CITY OF HOBART

Special City Planning Committee Meeting

3.1.1 34 Proctors Road, Dynnyrne - Partial Demolition File Ref: F21/83776

34 Proctors Road, Dynnryne - Partial Demolition

Figure 3: The chimney that has been removed is shown dashed on this front elevation plan.

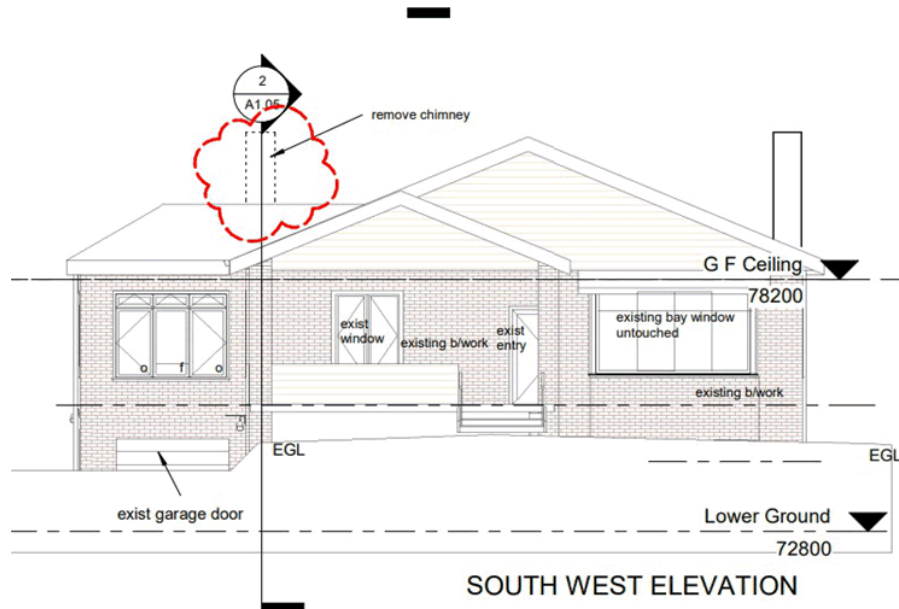
The chimney is a period feature/fabric of the Californian Bungalow which contributes to the historic cultural heritage significance of the precinct. The applicant has not articulated any environmental, social, economic or safety reasons of greater value to the community than the historic cultural heritage values of the place. A prudent or feasible alternative would have been to retain and support the chimney as required by HER 11 of PLN-19-485. The replacement portion of the building (without a chimney) is not more complementary to the heritage values of the precinct.

The 'proposed' demolition of the chimney fails to satisfy E 13.8.1 P1 of the Historic Heritage Code of the Scheme. This application is recommended for refusal. The recommendation for refusal is consistent with written advice previously given to the applicant by the Cultural Heritage Unit.
